**RESOLUTION ON APPEAL OF FLOODPLAIN PERFORMANCE STANDARDS AND  
REQUEST FOR VARIANCE FOR THE CENTRAL IOWA WATER TRAILS  
SCOTT AVENUE PROJECT (DES MOINES MUNICIPAL CODE  
SECTIONS 50-35(C) AND 50-34(14))**

RE: Central Iowa Water Trails - Performance Standard Section 50-34 (14) Variance Request

RE: Iowa DNR Joint Application 2021-0174 (Des Moines Area Metropolitan Planning Organization's Des Moines River Trail Activation and Under Scott Avenue Low Head Dam Modification Project)

RE: Scott Avenue Dam Modification Project Floodplain Rise Justification (Iowa DNR Joint Application 2021-0174)

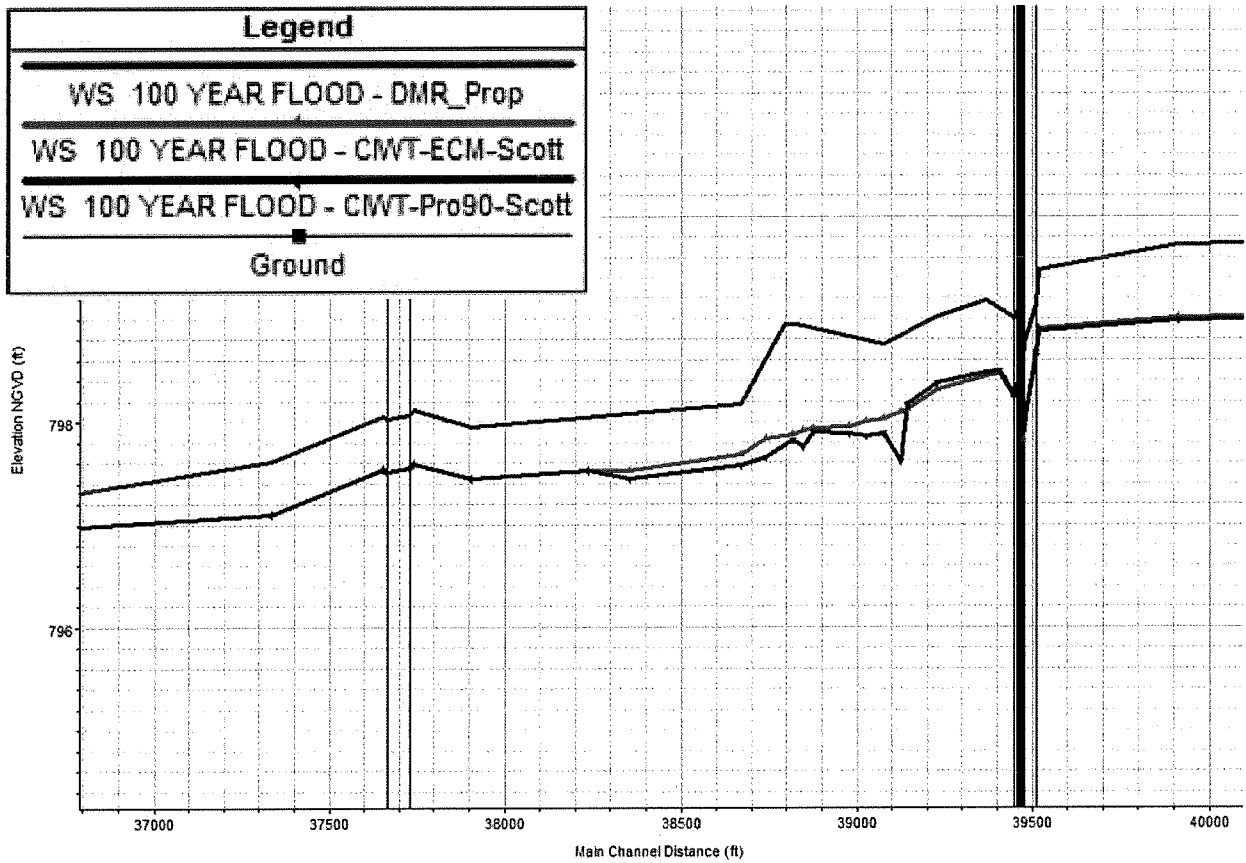
While flood levels related to the Project result in a non-zero increase (See attached Figure 1 and Table 1) ft between stations 39,145 ft and 39,511 ft (366 ft) during the encroached 1-percent annual chance event the increase is completely contained by the Des Moines Levee System. The maximum increase is 0.07 ft under the Scott Avenue Bridge – contained by Abutments – and over a channel length of 1 ft. In other places along the impacted reach the increase is 0.01 ft and 0.06 ft. The increase related to the Project does not propagate further upstream nor downstream from the Project reach. Furthermore, the current and ongoing Des Moines Levee Reach C Design and Construction project has been shown to be able to absorb the increase related to the CWIT Scott Avenue Project without impacting the levee's performance, minimum freeboard criteria, or certification eligibility.

After numerous attempts to meet the project goals and maintain a no rise, a 0.07' increase has been determined to be the minimum increase achievable over a 1 ft length of channel under the Scott Ave Bridge. The increases in the remainder of the reach are between 0.01 ft and 0.06 ft. The levee's future design accommodates this increase so no additional flood hazard will be created. T

This application includes a request for a waiver from meeting 567 IAC 72.11(1)a., and 567 IAC 72.9(1), due to the project expected to cause an increase in the 1% annual recurrence interval flood (100 year flood). Conditions that need to be met for the department to grant a waiver from Iowa Administrative Rules include:

- 1) The increase in flood height is limited to between the project and the Scott Avenue Dam (any increase in the extent of impact may require additional review and additional requirements/conditions)
- 2) Proposed mitigation of the rise must include completion of the future (currently named phase c) levee project (that will provide 3 foot of freeboard over the 100 year flood event) for the limits of this project in advance of this project starting, or providing an EAP or flood fighting operation plan modification addressing the increased risk to the levees through the impacted area.
